December 9, 2020

This letter comprises the comments of the Pacific Gas and Electric Company (PG&E), San Diego Gas and Electric (SDG&E), and Southern California Edison (SCE) in response to the United States (U.S.) Environmental Protection Agency (EPA) and U.S. Department of Energy (DOE) on the Draft 1 of the Version 4.0 ENERGY STAR® Specification and the Draft 2 Test Method to Validate Demand Response for Residential Water Heaters.

**ENERGY STAR draft 1 Version 4.0 Specification for Residential Water Heaters**

## **Draft 2 Test Method to Validate Demand Response for Residential Water Heaters**

**Figure 1: V4.0 Efficiency Criteria and ENERGY STAR Heat Pump Water Heaters**  
 Source: ENERGY STAR Draft 1, Version 4.0 data package.

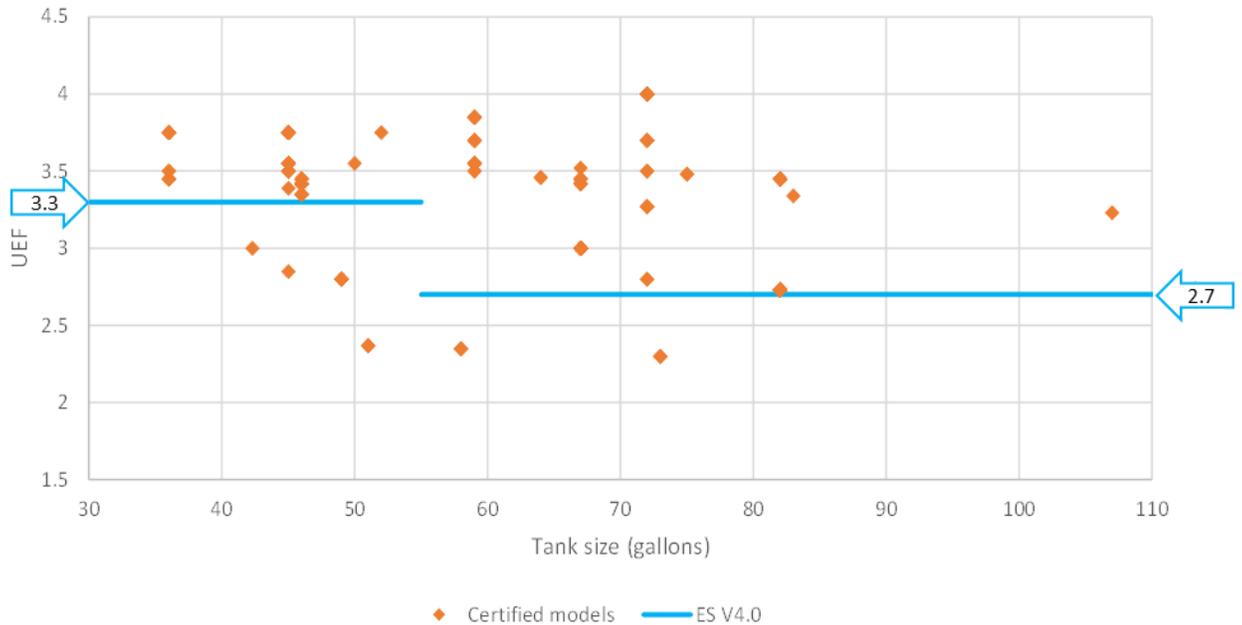
The data package provided by EPA (see Figure 1) suggests the UEF levels EPA has proposed in Draft 1 of Version 4.0 are an attempt to recognize the increased performance levels of the well-established class of unitary ESWHs rated to operate at 240 V (hereafter referred to as U24WH), as well as to also continue to support the newer and less efficient class of split-system HPWHs. The CA IOUs agree that the observed progress in both product classes are positive developments and should be supported by ENERGY STAR.

Complimentary to the ENERGY STAR data package, 91 percent of U24WHs currently listed in the DOE Compliance Certification Management System (CCMS)/Air-Conditioning, Heating, and Refrigeration Institute (AHRI) databases and rated as having tanks greater than 55 gallons would still be able to qualify for ENERGY STAR under the minimum UEF of 2.7 proposed in Version 4.0. Conversely, only 13 percent of listed models with tanks rated at less than or equal to 55 gallons would still be able to qualify under the minimum UEF of 3.3 proposed for this size category. If EPA were to instead also increase the UEF requirement for the units greater than 55 gallon U24WH to 3.3, it would significantly increase the energy savings associated with the ENERGY STAR label for these products, and more than half of U24WH models currently on the ENERGY STAR Qualified Products List (QPL) would still qualify.
